CORPORATION
Crystal River Unit 3
Docket No. 90-302

Subject: License Amendment Request #224, Revision 0
Reactor Building Fan Starting Logic Modification

**LICENSE AMENDMENT REQUEST #224
REVISION 0**

**REACTOR BUILDING FAN
STARTING LOGIC MODIFICATION**

Figure 1

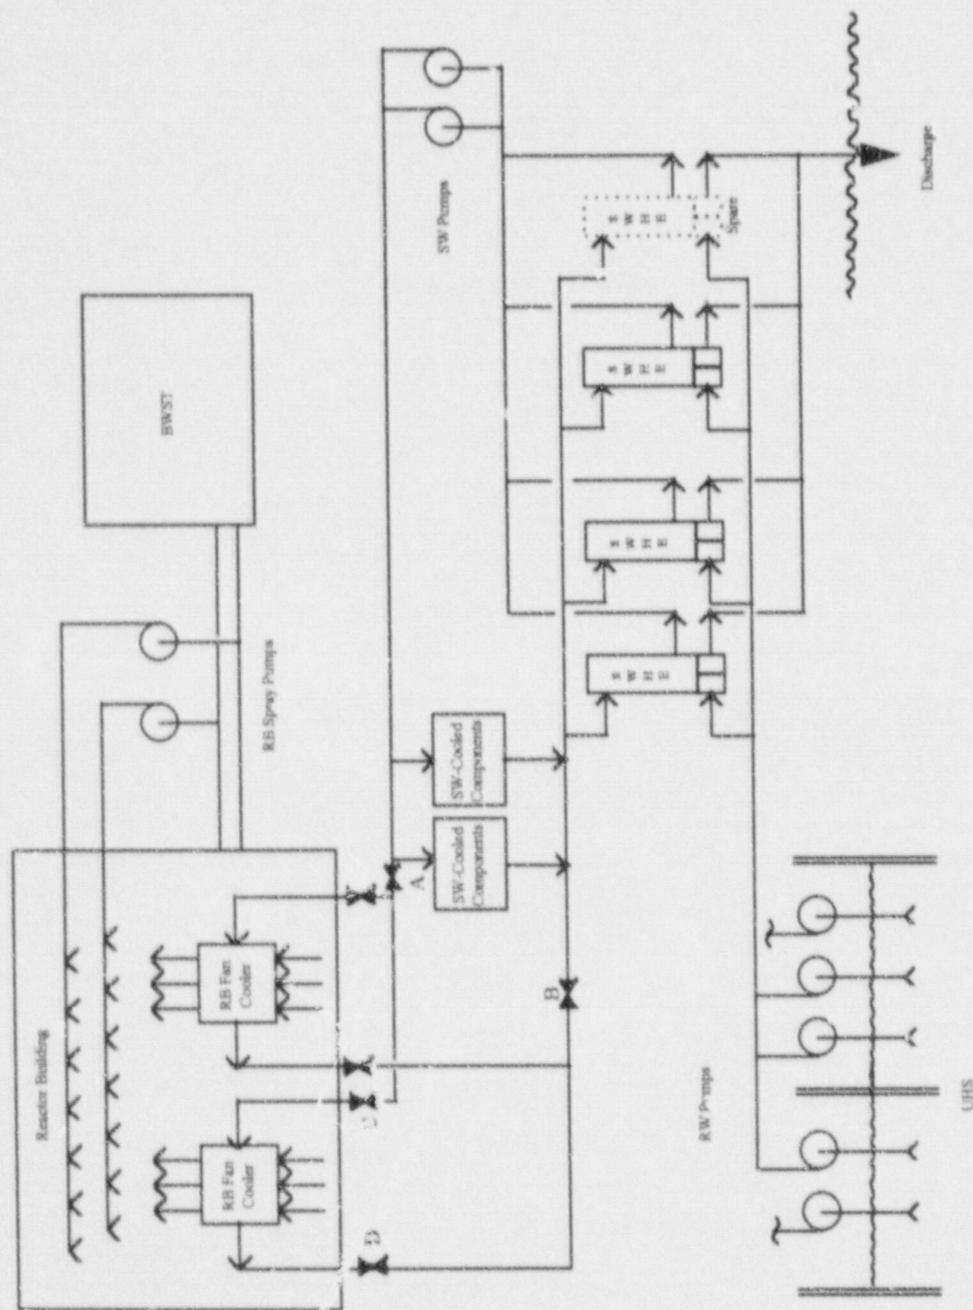
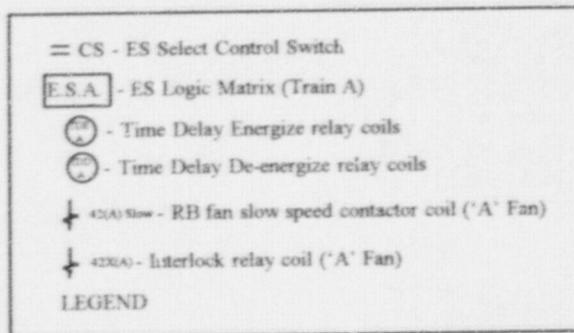
The RB Fan Coolers are part of the RB recirculation subsystem (AH-XA). This system is comprised of the RB Fans and motors, associated cooling coils, dampers, motor coolers, and ductwork. The RB Fans draw air from various locations throughout the RB. The air is drawn across the coils of the RB Fan Coolers to remove sensible and latent heat. Under normal cooling conditions, the coils are supplied with Industrial Cooling (CI) System water. In the event of an actuation of the RBIC System, the coils are automatically changed over to the SW System cooling water supply. A sketch of the RB Fan Cooler interface with the SW and RW System is included in Attachment D, Figure 1.

Figure 2

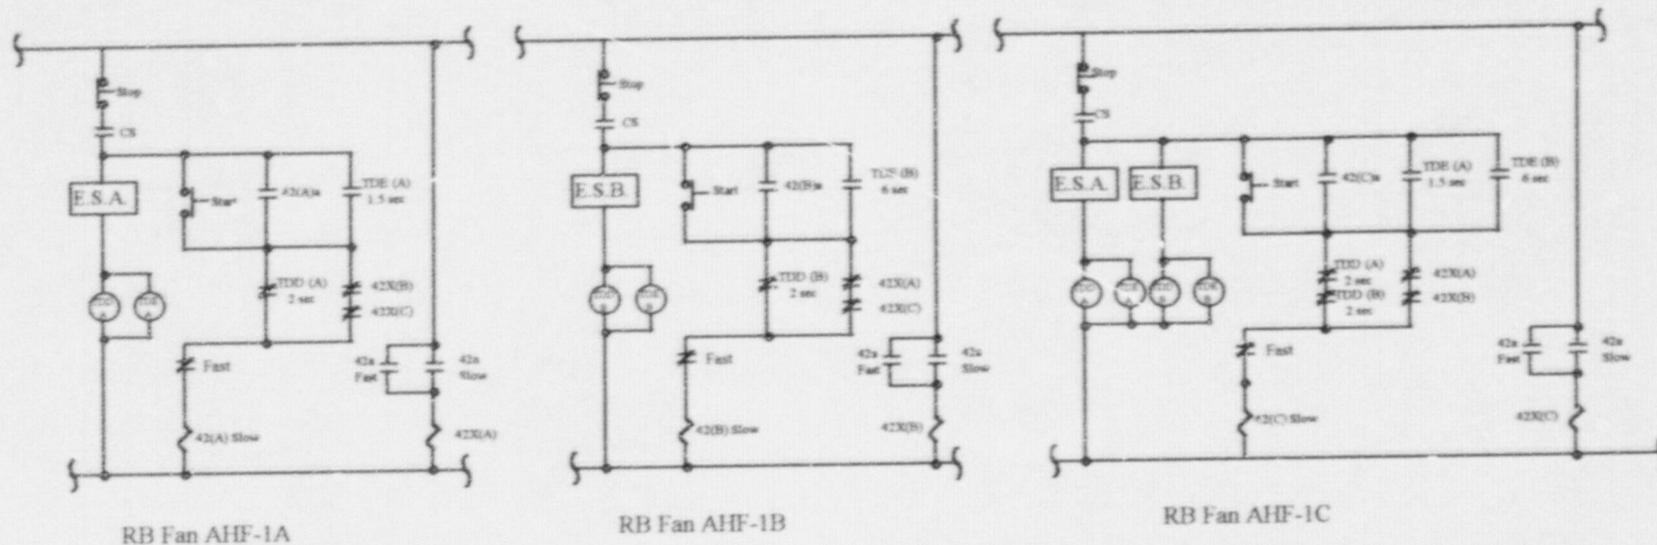
The modified fan motor starting scheme is shown schematically in Attachment D, Figure 2. The modification permits only one RB Fan to start and run in slow speed in response to an RBIC actuation signal. This starting logic is accomplished through a circuit that provides a 'lead' and 'back-up' arrangement for the ES selected RB Fans. The operating status of the lead fan determines whether to start the backup RB Fan. In the event that the lead RB Fan fails to operate, the ES start of the backup RB Fan is enabled and restart of the lead RB Fan is prevented. For purposes of this discussion, the 'A' train RB Fan will be selected as the lead fan. The lead fan is selected by setting its time delay to approximately 1.5 seconds. The backup fan's time delay is set at approximately 6.0 seconds. The shorter time delay for the lead fan is the only difference between the lead fan and the backup fan circuit.

When RB pressure exceeds 4 psig, an ES actuation and RBIC signal would be generated and the operating RB Fans would trip from fast speed. Then, a slow speed start signal is generated, energizing the RB Fans start timer relays (TDE-A for 'A' fan and TDE-B for 'B' fan on Figure 1 in Attachment D). After a short time delay (approximately 1.5 seconds), the TDE-A relay changes state, closing the relay contact TDE(A). If no other RB Fans are operating in fast or slow speed, contacts '42a Fast' and '42a Slow' for 'B' and 'C' trains will be open and therefore relays 42X(B) and 42X(C) will be de-energized and contacts 42X(B) and 42X(C) in the 'A' fan motor start circuit will be closed. This energizes the coil '42(A) Slow' which closes the fan starter contactor and starts the 'A' RB Fan.

If the 'A' fan fails to start as indicated by the starter contactor not closing, the 'B' fan would start as follows. When the start signal was generated from the RBIC signal, the TDE-B time delay relay was energized. After 6 seconds, the relay would change state, closing the TDE(B) contact in the 'B' fan start circuit. Since 'A' fan did not start, and 'C' fan is not running, the 42X(A) and 42X(C) contacts would be closed, and coil '42(B) Slow' would energize, starting the 'B' fan motor.

The time delay relays TDD(A), TDD(B) and TDD(C) are in the circuit to allow the manual start of a second RB Fan after RBIC is reset. For the 'A' RB Fan, this relay is energized when an RBIC signal is present and contact TDD(A) is open. When RBIC is reset, relay TDD-A is de-energized, and after a short time delay, the contact TDD(A) closes. The closed TDD(A) contact allows continuity to the '42A Slow' relay coil through the '42(A)a' seal-in contact even with another fan operating (which opens contact 42X(B) or 42X(C)). This feature allows the start of a second RB Fan under operator control later in the event when heat load from the RB is reduced.

This modification adds three relays to the 'A' and 'B' fans and five relays to the 'C' fan control schemes. For the 'A' and 'B' fans there are two timing relays, one is a time delay to energize relay and one is a time delay to de-energize relay, these two relays require 8 watts for each relay. For the 'C' fan there are four timing relays, two for each of the ES actuation signals and are the same as those used on the 'A' and 'B' fans. The final relay, which is required for all three fans, is an auxiliary relay that requires 23 watts of power for operation. The auxiliary relays receive their actuation directly from the fast and slow speed contactor contacts. Calculations confirm that the existing Control Power Transformers have adequate capacity for the additional 39 watts for the 'A' and 'B' fans and the 55 watts for the 'C' fan. Existing control circuit fuses are sufficiently sized to accept the additional load and adequately protect the new relays.
